PROJECT
 West Hampstead Square

TITLE
 Block C Elevations

JOB NO.	DRAWING NO.	REV
12-316	PL-12	D

SOUTH ELEVATION

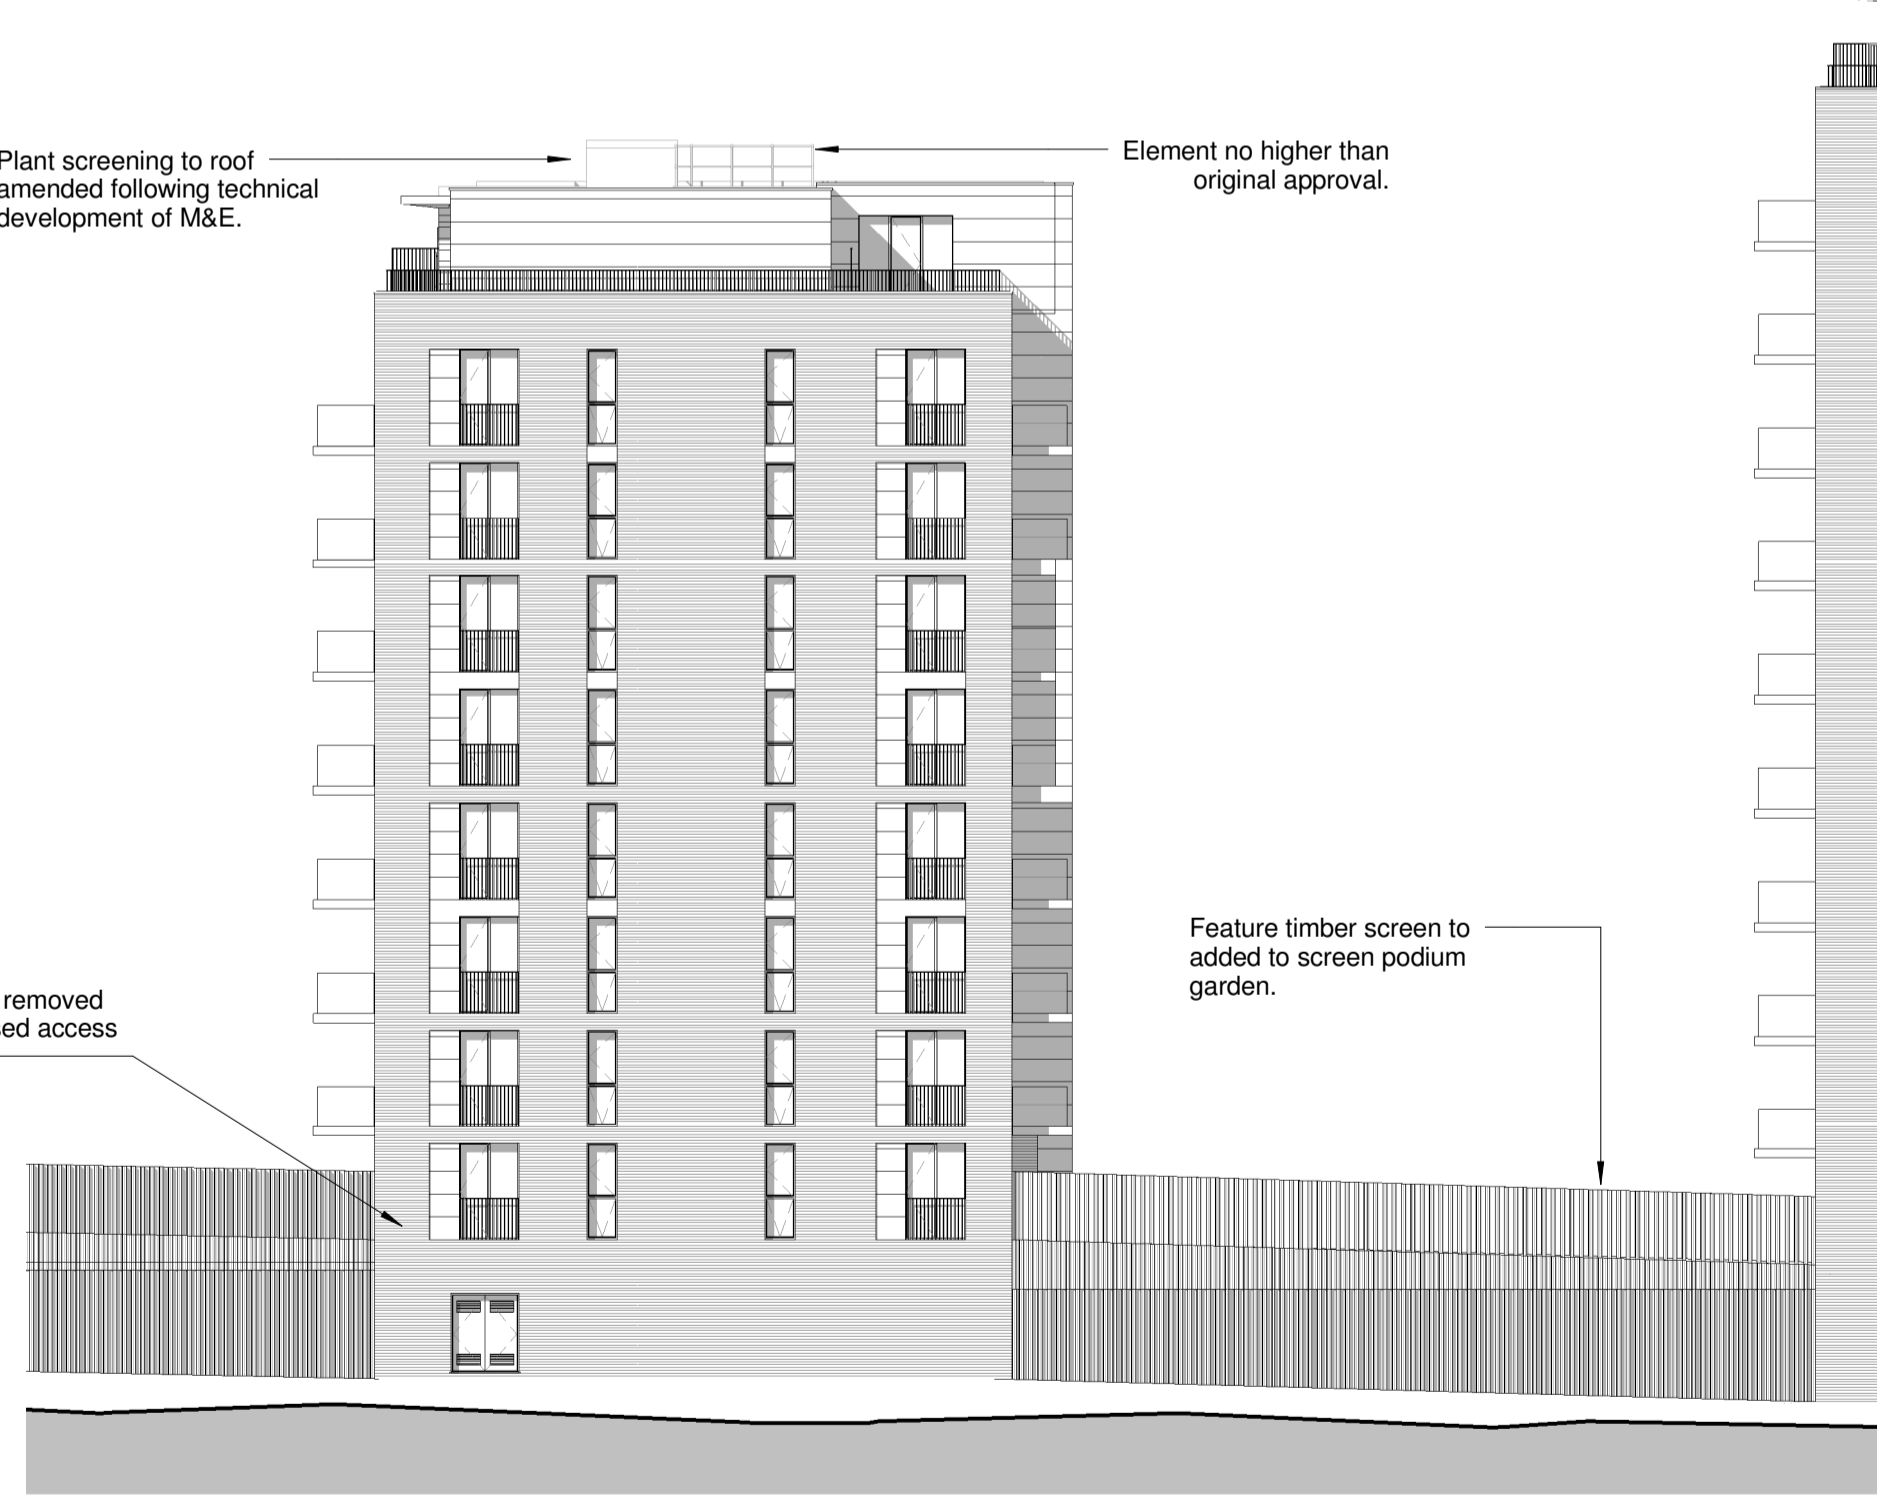
GF Fenestration reduced and rationalised to promote closer architectural relationship to rectilinear elevations above.
